Clean Energy Council submission to the Australian Energy Market Operator Draft Determination: Amendment of the Market Ancillary Service Specification - DER and general consultation

Figure 4.1 — Example frequency response for a decrease in frequency for an inverter that has a reduced output

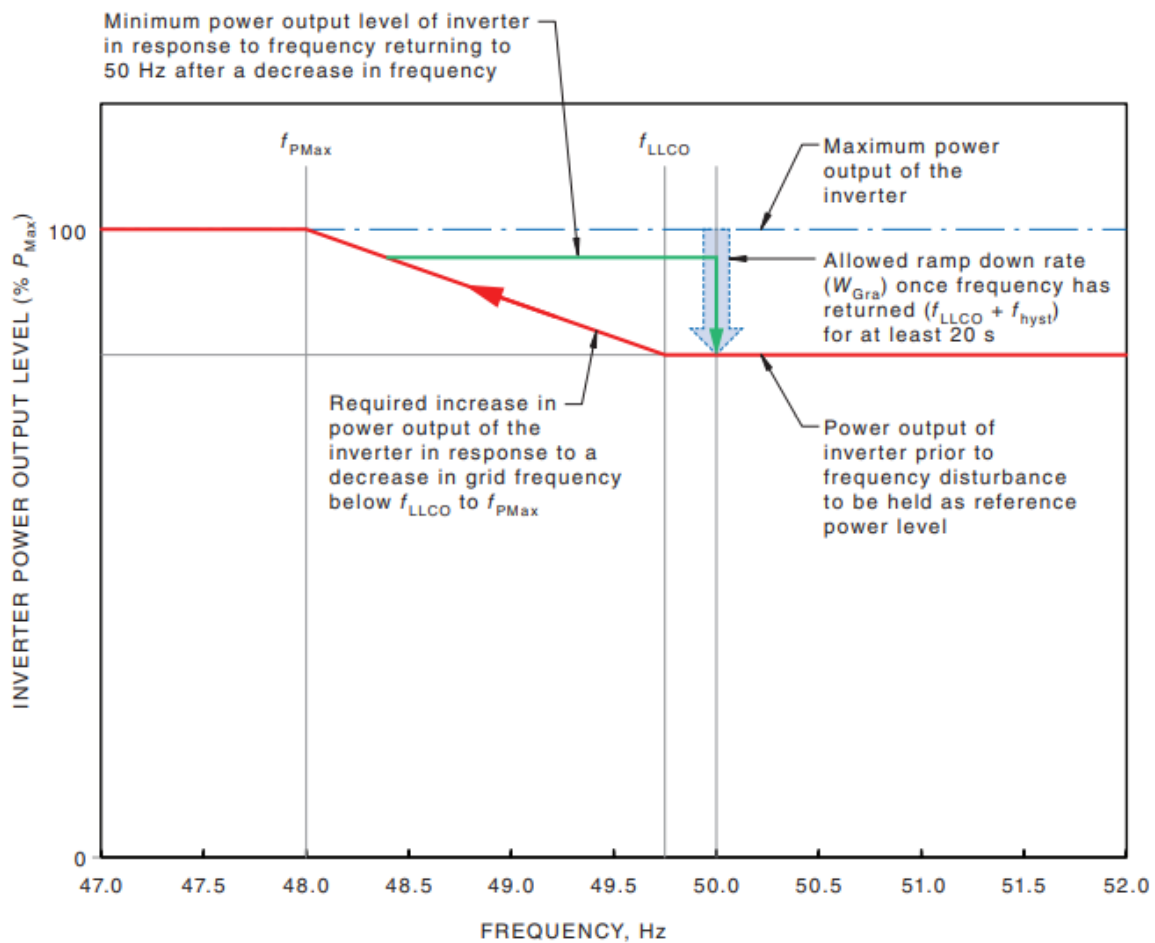
Thus, when frequency falls below the continuous operation range, inverters are required to increase their output if it was previously curtailed by volt-var and/or volt-watt response modes as illustrated, below.

The test procedure described in clause J.3.4, raises the voltage into the volt-watt region and then reduces frequency down below 48Hz to confirm this behaviour. This is a mandatory response. Delivering an FCAS response in advance of this would not necessarily conflict with AS/NZS 4777.2:2020.
